Access Compliance Report Public Rights-of-Way (Curb Ramps)

Main Street: HEWES_ST Cross Street: E_SPRING_ST Location: SW

ADA ID: RPRK211223115345 Ramp Type: Type 1 - Perpendicular Diagonal Initial Pass/Fail: Pass Overall Compliance: No Severity Score: 9

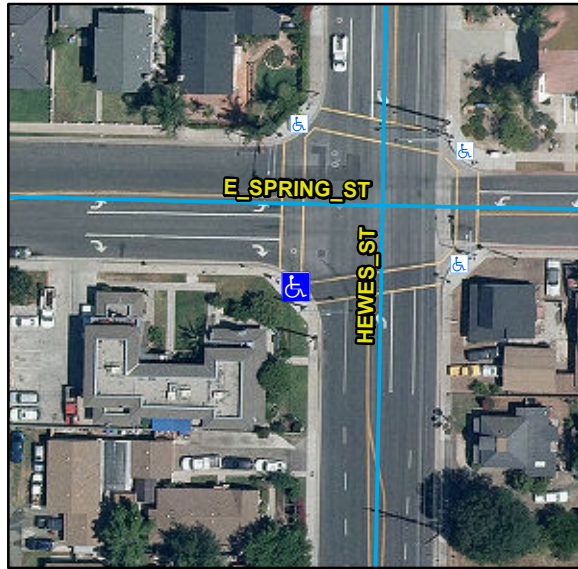
R304.2.1, R304.5.4, R304.5.3, STD 1115

Compliance	Description	Data	Compliance	Description	Data
N/A	Ramp Length (in)	62	N/A	Flare Type LT	
Yes	Ramp Width (in)	48			Sloped
Yes	Ramp Run Slope (%)	7.8	N/A	Flare Slope LT (%)	9.7
Yes	Ramp Cross Slope (%)	1	N/A	Flare Traversable LT	No
N/A	Landing Present	Yes	N/A	Flare Type RT	
N/A	Landing Length (in)	47			Sloped
Yes	Landing Width (in)	48	N/A	Flare Slope RT (%)	5.4
Yes	Landing Run Slope (%)	0.7	N/A	Flare Traversable RT	No
Yes	Landing Cross Slope (%)	1.3	Yes	DWS Provided	Yes
N/A	Landing Movement Obstructed?	Yes	Yes	DWS Contrast	Yes
	Landing Movement Type	Curb	Yes	DWS Length (in)	36
N/A	Landing Shared	No	Yes	DWS Full Width	Yes
Yes	Clear Space	Yes	Yes	DWS Offset Left (in)	0
Yes	Clear Space To Crosswalk (in)	48	Yes	DWS Offset Right (in)	N/A
N/A	Marked Crosswalk 1	Yes	N/A	Marked Crosswalk 2	Yes
	Crossing 1 Direction	E		Crossing 2 Direction	N
	Marked Crosswalk 1 Width (in)	144		Marked Crosswalk 2 Width (in)	144

Yes	Ramp Inside Crosswalk 1	Yes	Yes	Ramp Inside Crosswalk 2	Yes
	Crossing 1 Slope (%)	5.4		Crossing 2 Slope (%)	3.6
	Crossing 1 Cross Slope (%)	2		Crossing 2 Cross Slope (%)	1.4
Yes	Gutter Ponding	No	Yes	Curb Slope	0.9
Yes	Gutter Lip Height (in)	0		Road Run Slope (%)	1.2
No	Gutter Run Slope (%)	10.6		Road Cross Slope (%)	4.3
No	Gutter Cross Slope (%)	2.1			
Yes	Overall Surface Condition: Acceptable		Yes	Perp Joint Present	Yes
	Cross Gutter Present?	No		Spandrel Present?	No
	Replace Cross Gutter?	N/A		Replace Spandrel?	N/A

Remove & Replace Landing. Remove & Replace Gutter.
